LIGHT RAIL PERMITTING ADVISORY COMMITTEE MEETING

Subject: December 3rd, 2014 Advisory Committee Meeting

SOUTH BELLEVUE SEGMENT PRE-DEVELOPMENT REVIEW

ST Responses to South Bellevue Segment Pre-Development Review May 13, 2014

Barrier detail

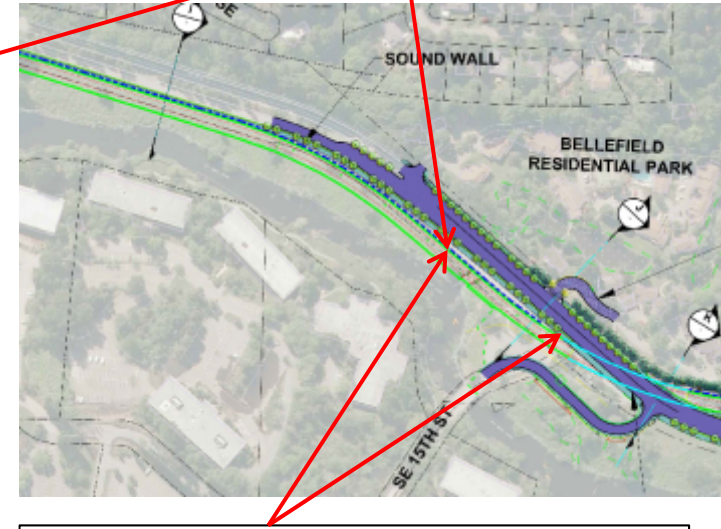
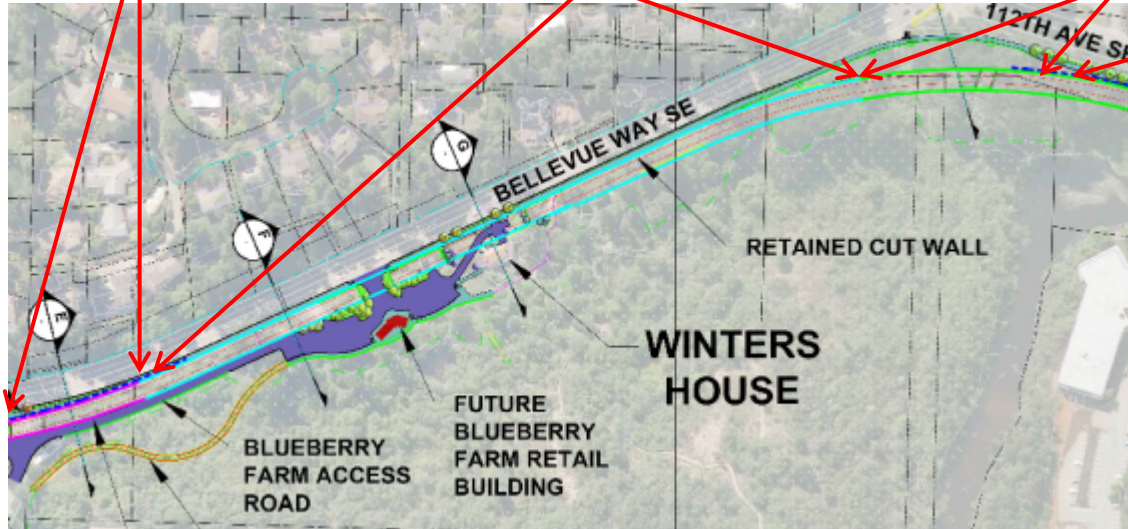
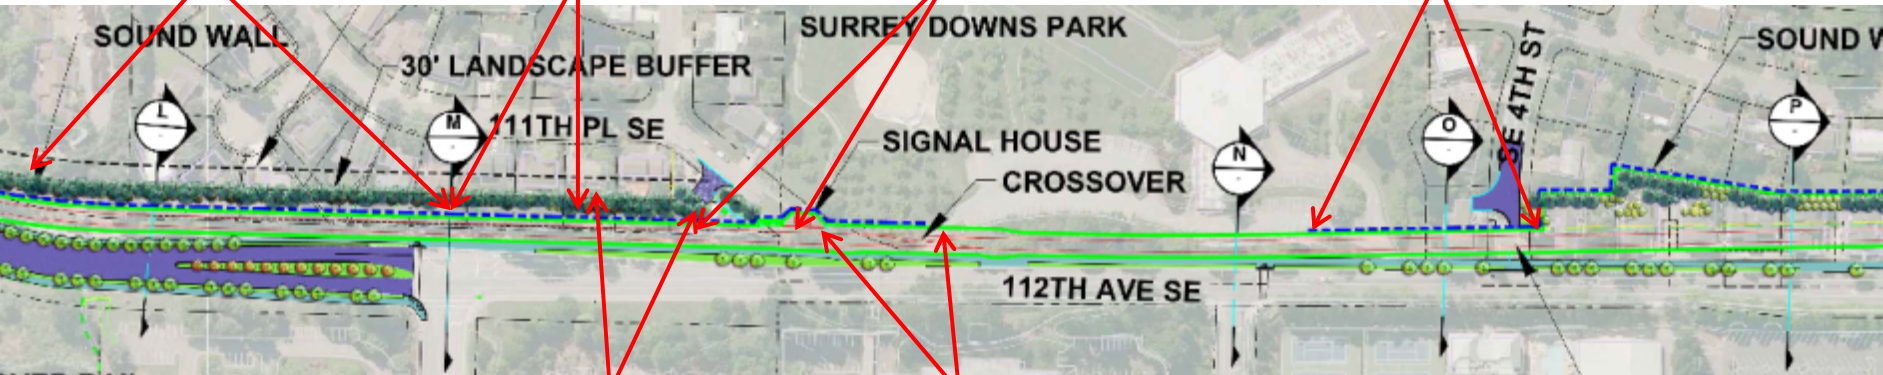
Mr. Jackson asked if Sound Transit has come up with a form liner for the concrete panels. Mr. Cornish said Sound Transit is proposing a horizontal raised relief pattern be utilized.

Mr. Glass commented that the sound wall patterns look more like something one would expect to see on the side of a highway rather than running through a residential neighborhood. Stone or brick would be more in keeping with the look and feel of a residential neighborhood. Mr. Cornish said there was a lot of talk about the use of stone or brick in conjunction with the East Main station and the architects are looking at that issue. He said he would ask the architects about using it in the sound walls as well.
